Appendix I

Stakeholder Meeting Presentations and Minutes

Warren Avenue Bridge Pedestrian Improvements

Alternative 1

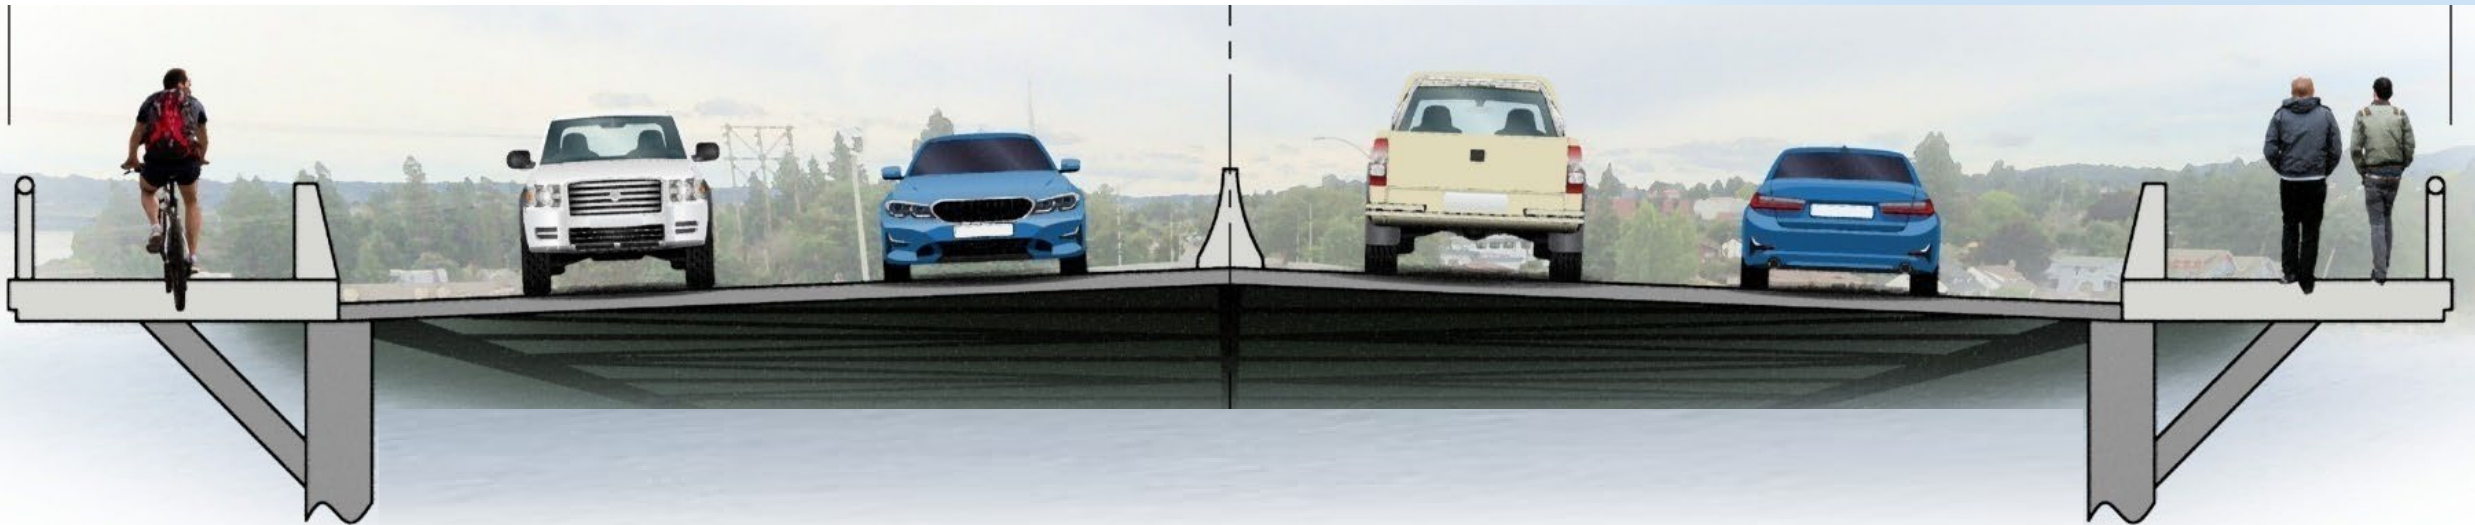
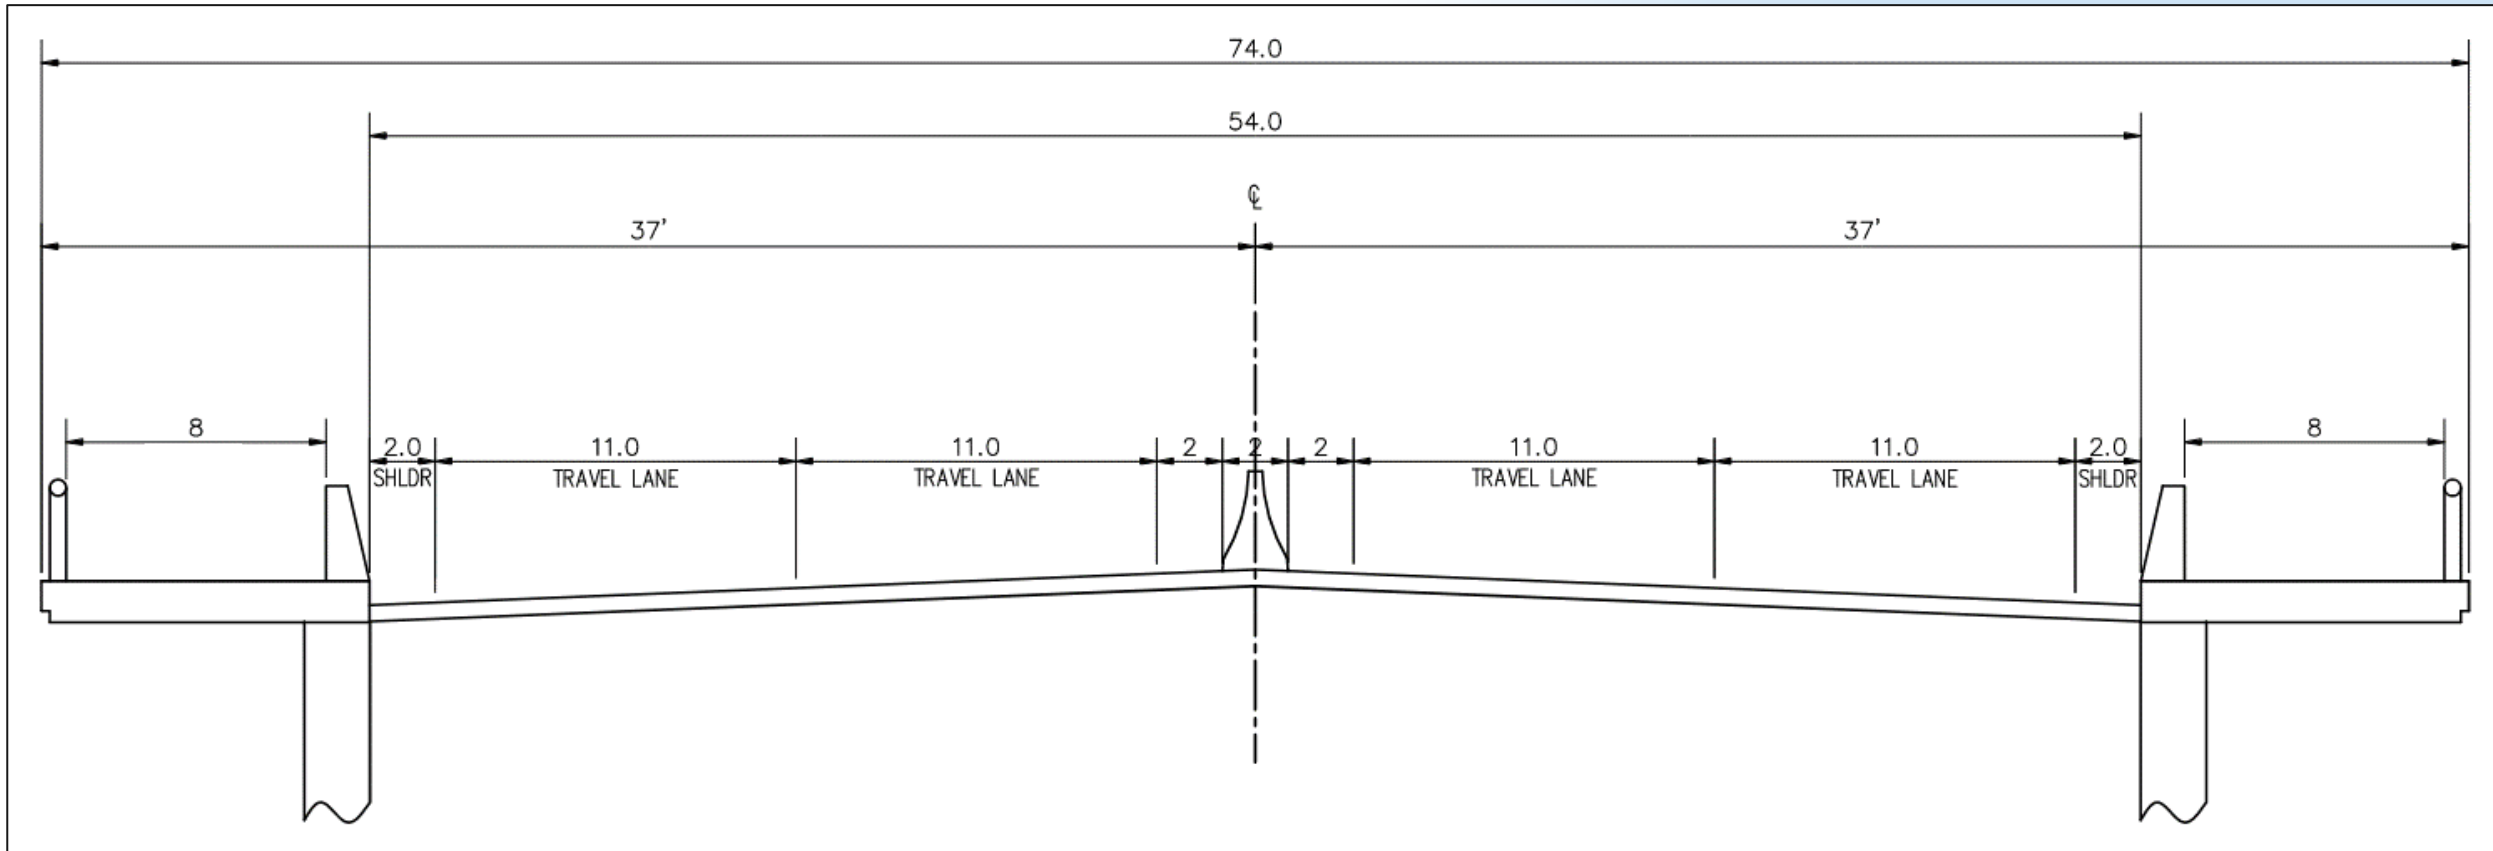
- Requests that alt 8 remain up for discussion.
 - **Response (Dan Penrose):** Alt 8 was eliminated because it requires rope access.
 - **Response (Ned Lever):** It seems reasonable to follow up with more information on Alt 8. Requests a clearer picture from WSDOT on whether there is any wiggle room on alt 8's feasibility.

- **Response (Aaron Knight):** The team held a meeting with WSDOT and it was stated that alternatives that require rope access are not acceptable.
- Requests that slide 6 depict a graphic showing the existing infrastructure on the Northwest corner of the bridge.

Alternative 7

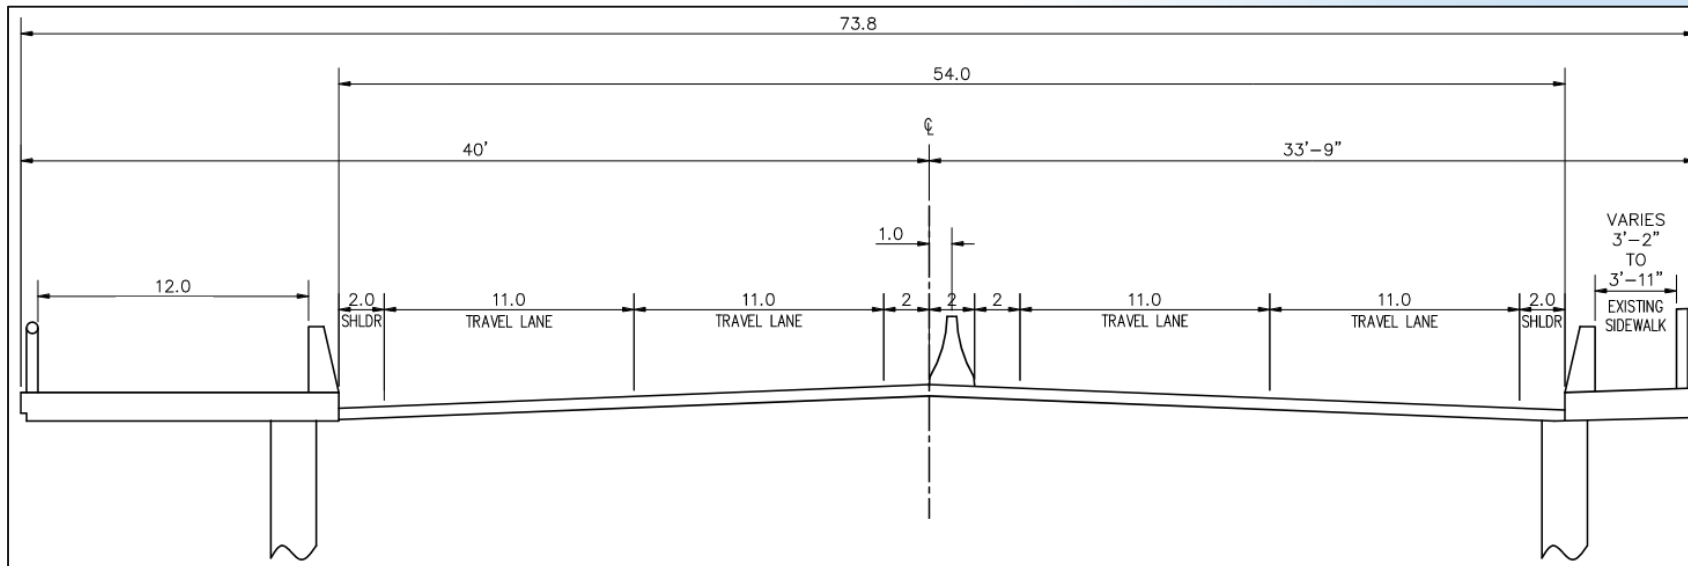
- Requests that alt 7 be rejected because it does not meet minimum accessibility requirements on both sides of the bridge. Safety complaints have been raised by the ADA committee about a lack of space for pedestrians, wheelchairs, and strollers to pass.
 - **Response (Aaron Knight):** The purpose of the meeting is to focus on understanding the fatal flaws. Requests that the committee keep questions to the reasoning behind assigning the fatal flaws and/or any disagreements in what the flaws are.

Alternative 2

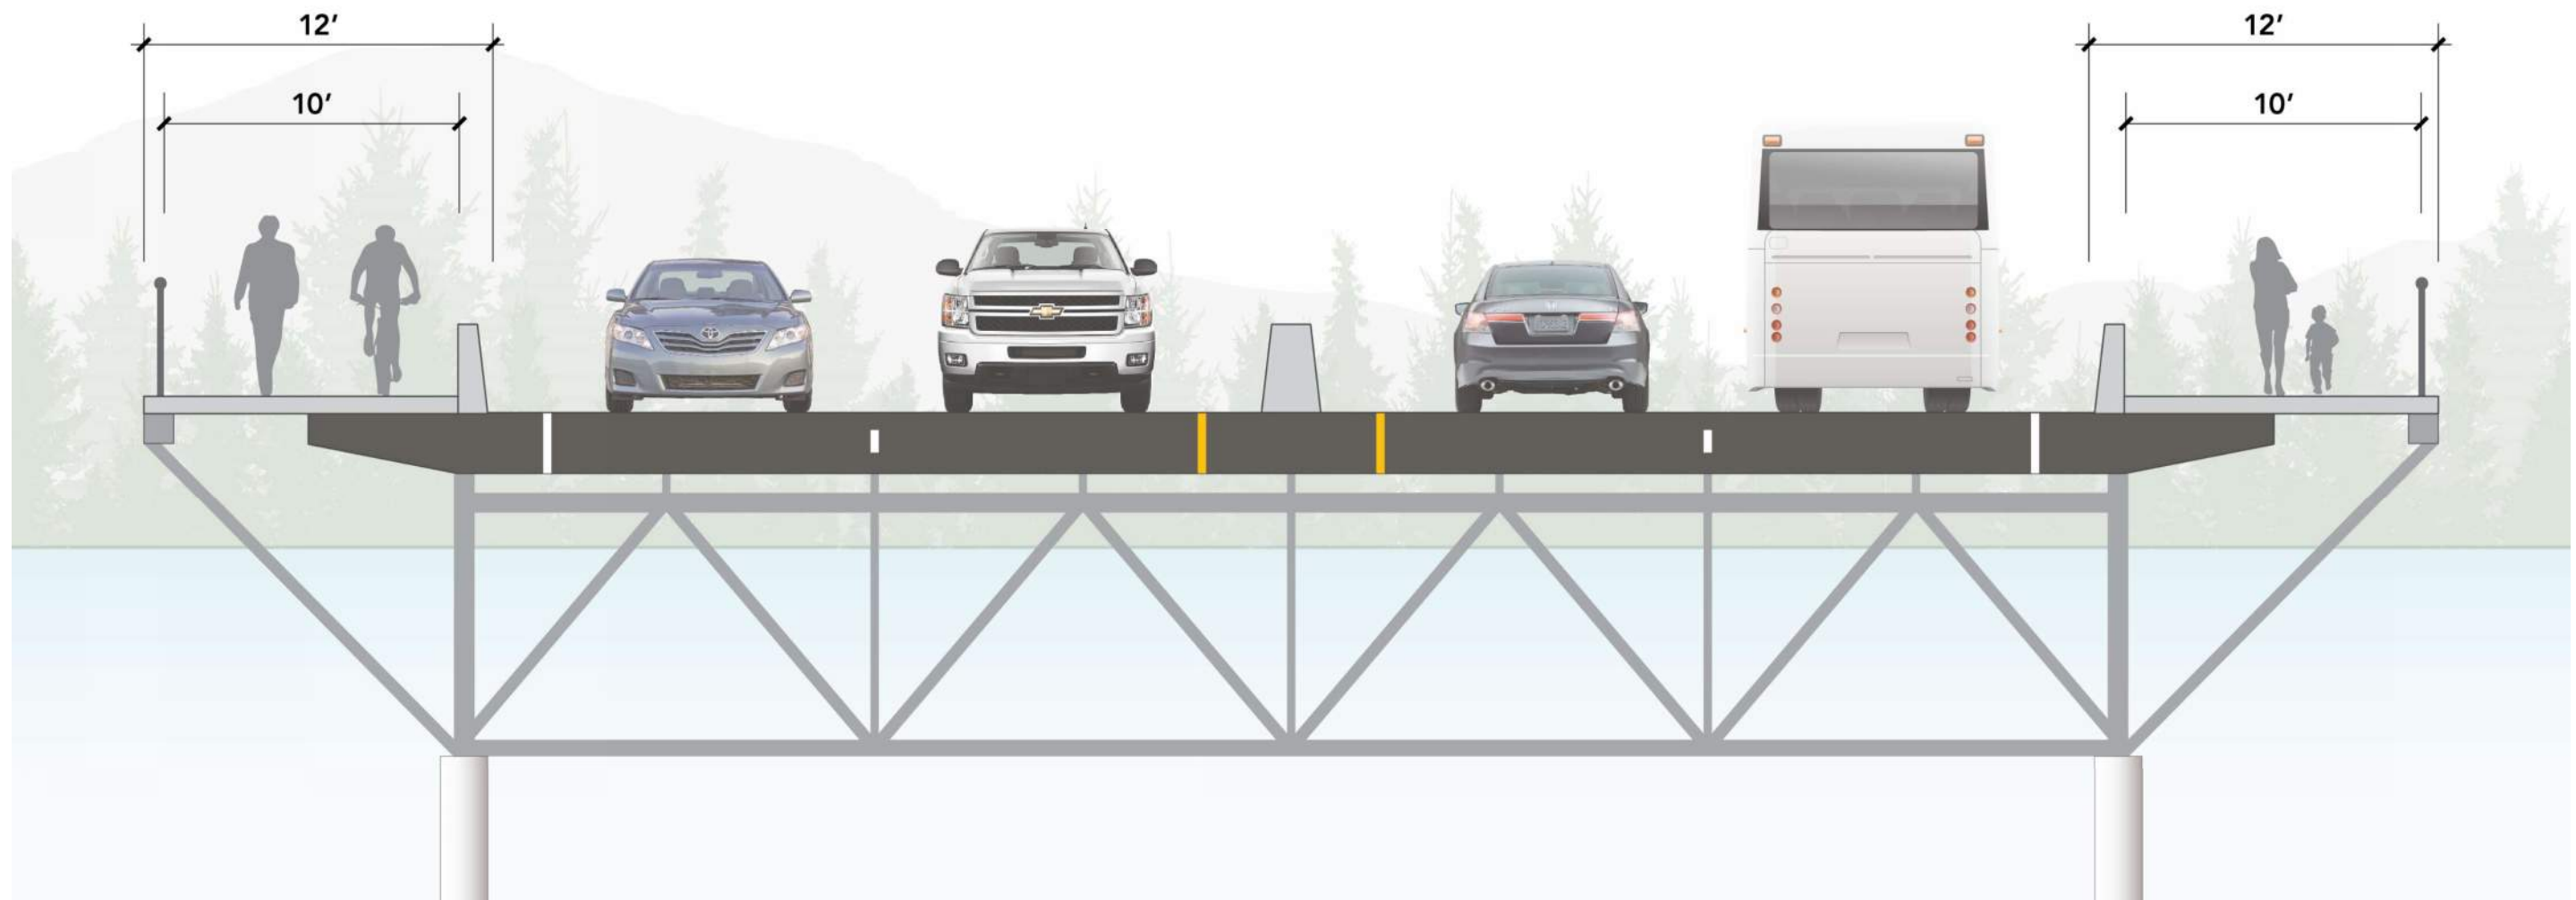
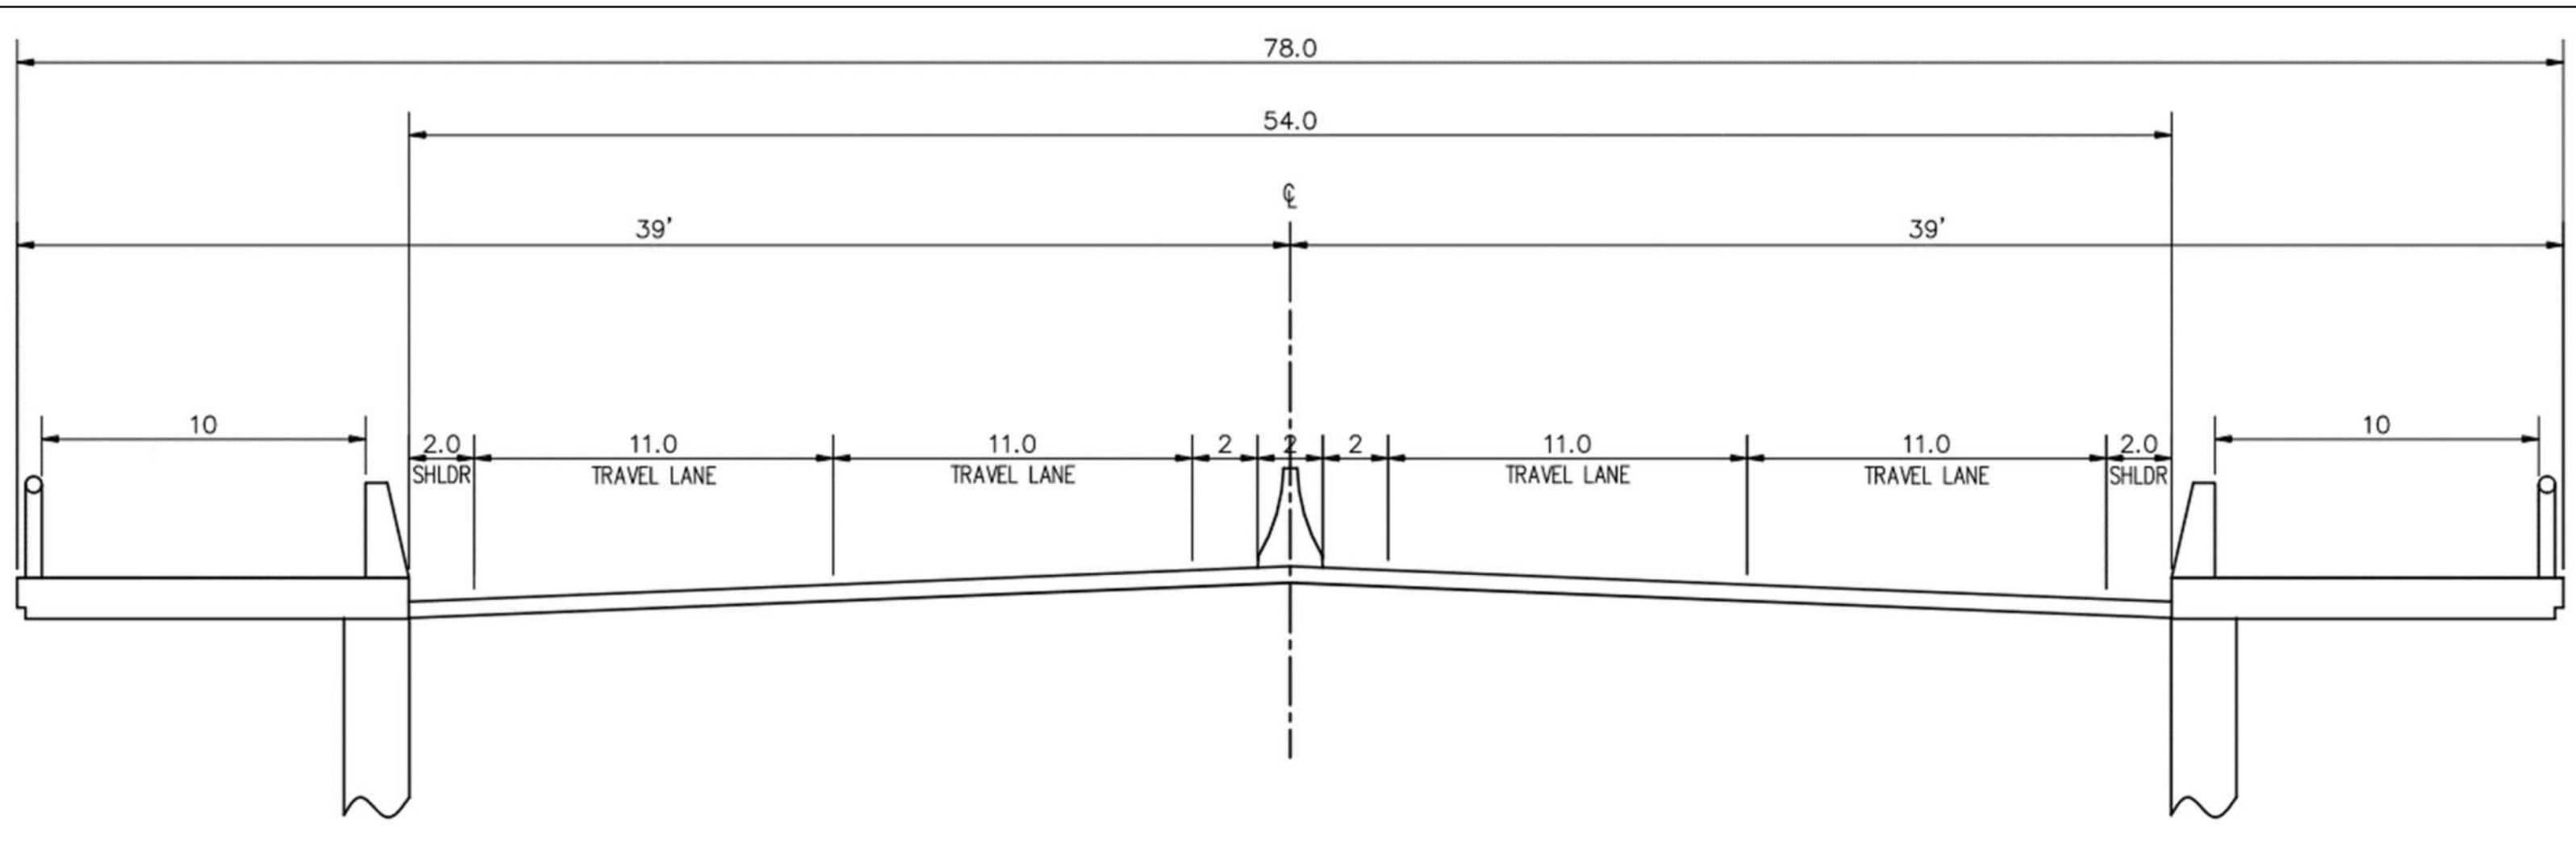
- Referring to alternative 2, for a 24 ft length overlook you would have 16-foot-wide shared use walkway with benches etc. Correct?
 - **Response (Aaron Knight):** Yes, it's intended to be a gathering/rest area where the views from the bridge can be enjoyed.

- **Response (Jeff Coughlin):** Would taking alternative 2 and making it a one-sided pathway reduce the cost by approximately 8 to 10 million to get us to that 26.5 million price range?

- **Response (Aaron Knight):** It is estimated that reducing the pathway to one side would cut the cost by approximately 40%. One side would get us closer to the 26.5 million, but we have discussed that the tunnel would be a necessity for that alternative which adds costs
